# Possibilities for York Station?

This discussion paper contains outline suggestions for bus, taxi, cycle, and pedestrian provision at the south end of York station, and is meant to stimulate discussion of how the council's current proposals might be improved upon.

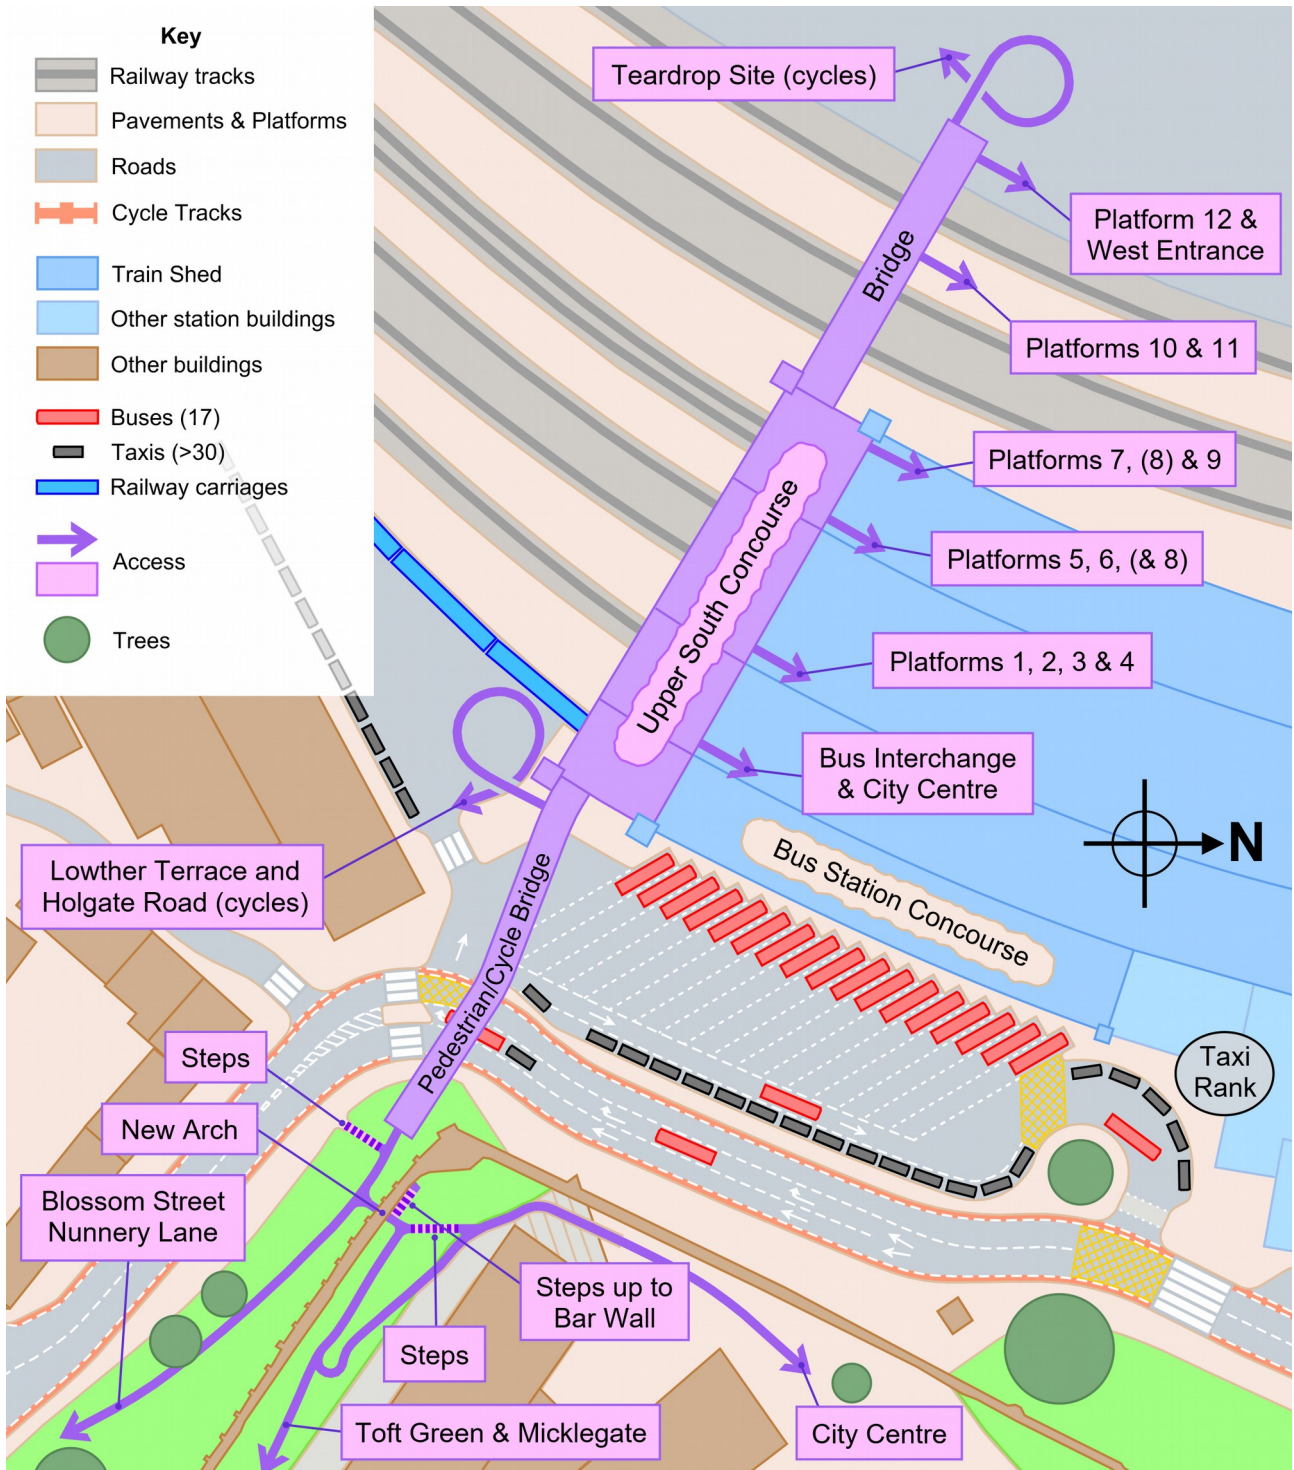
This sketch map covers two sets of ideas, the first for a bus station and taxi rank, and the second for a bridge connecting Queen Street, the bus and railway stations, and the Teardrop site. The bridge proposal is distinguished by its general pink/violet/purple theme.

4. Given the projected *three-fold* rise in railway passenger traffic, and the aspiration for greater public transport use, CoYC's Station Front Consultation proposals make inadequate provision for buses at the railway station.

7. This seems the only place for a bus station. One on the west side would be further from the city centre. Double deckers cannot pass through Leeman Road tunnel.

8. Proximity to the railway station is ideal from an integrated transport point of view.
9. The map shows space for 17 bays, but this is to illustrate what might be possible. It is not based on any assessment of the number required.

10. The bus station concourse goes inside the train shed, with access through the currently bricked-up arches in the train shed wall.
11. It is very doubtful whether there is enough space for a bus station and dedicated building between the train shed and Bar Walls. Putting the concourse inside the train shed makes enough space available.

18. The rank itself is in broadly the same area as the taxi rank in CoYC's Station Front Consultation proposals, but the queue is relocated to make space for the bus station.
19. There is room for a long queue, which ends close to the rank, and the rank is clearly visible from the head of the queue.

20. Further extension of the queue alongside the current Railway Institute buildings would be possible if need be. The total length of the queue in the map (over 30 taxis) is meant to show what would be possible, not how much is actually needed.
21. The taxi rank and bus station share space efficiently.
22. Road junctions are simpler because buses and taxis share the same entrance and exit.
23. Safety: queuing drivers can get out and chat to each other on the pavement, conveniently located on their offside.
24. Separating the drop-off (not shown – it might perhaps be outside the Portico) from the taxi rank makes it possible to fit the bus interchange in.

26. Relocation of the bus hub further south strengthens the case for a crossing here because it gives a direct route between the hub and the Teardrop site.

33. Extending the bridge towards the Bar Walls would give pedestrians and cycles a grade separated way to cross the road between the station and the walls.

34. The bridge deck height would be similar to Queen Street Bridge (a little higher in the middle), and below the tops of the Bar Wall ramparts.
35. The extension is located so as not to obscure the view of the Bar Walls from the station front area.

39. From a purely functional point of view, a good solution would be a new arch through the walls. This is the solution shown on the map.
40. As an added bonus, this could give pedestrians direct access from the railway and bus stations to the top of the Bar Walls, up a new flight of steps.
